PLANNING, ZONING, & BUILDING DEPARTMENT  
 PZ&B Staff Combination Memorandum: Architectural Commission and Town Council

SUBJECT: ARC-23-164 (ZON-24-010) 1616 N OCEAN BLVD (COMBO)

MEETING: DECEMBER 15, 2023 ARCOM  
 JANUARY 10, 2024 TC

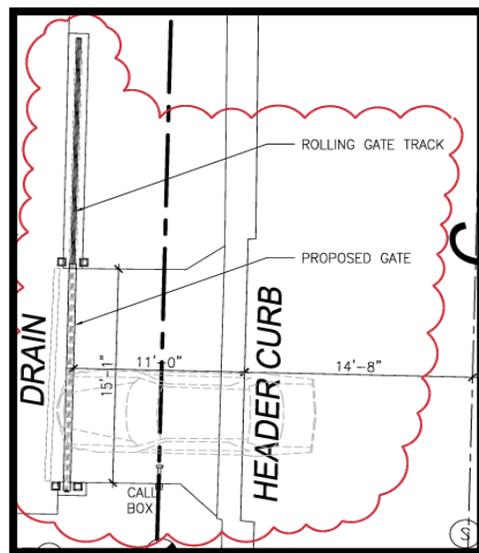
A preliminary review of the project indicates that the application, as proposed, appears to not be in accordance with the Town code. The below diagrams demonstrate the relief being requested by the applicant. Town code requires a nine feet wide and eighteen feet deep driveway area at driveway entrances. Both the north and south proposed vehicular gates do not meet that requirement. No changes to the landscape scheme or landscaped open space are planned. A variance for 9 feet and 11 feet of depth, for the south and north gates is requested
